RIBAUT COLUMN SHORELINE AND EMBANKMENT STABILIZATION

RE: National Park Service - Environmental Assessment (EA) for Ribault Monument
Shoreline and Embankment Stabilization Project at Timucuan Ecological and
Historic Preserve - Jacksonville, Duval County, Florida.
SAI # FL201001295099C

SUBJECT: National Park Service – Environmental Assessment for Ribault Monument Shoreline and Embankment Stabilization Project at Timucuan Ecological and Historic Preserve – Jacksonville, Duval County, Florida.
SAI # FL201001295099C

Re: St. Johns Creek, Replace Bulkhead at Ribault Monument

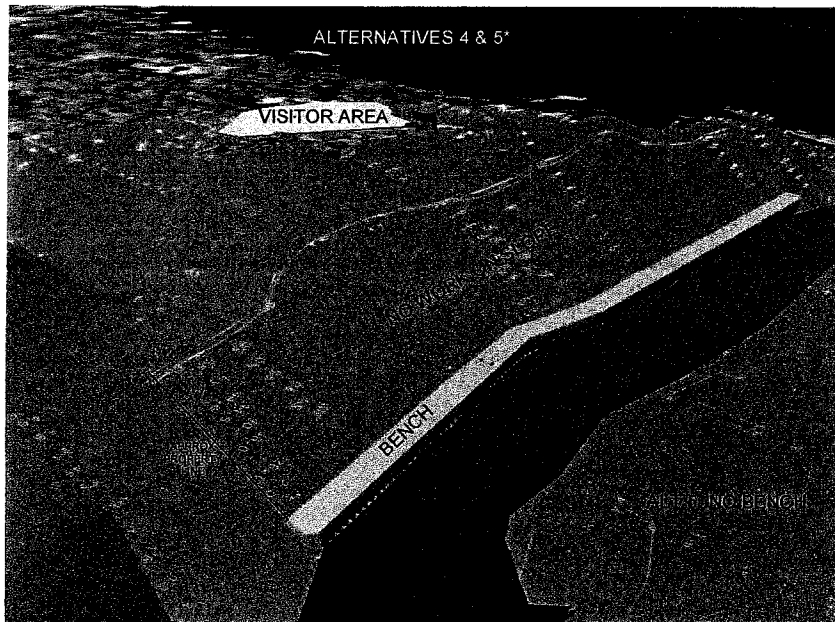
We offer this photo as testament to the sustained damages at the mouth of SJC.

We offer these photos as testament to the sustained damages within SJC.

Sand continues upstream 100 feet beyond Park boundary.

Based on the findings of the PEPC and our own research we request the St Johns Creek bulkhead project include a clean-up dredging that would remove the slope material referenced above in 1.2 and 1.4 and any new construction deposits to the chartered depth of (4) four feet MLW for the length of the new bulkhead and width of the creek, including deposits at the mouth into the St. Johns River.
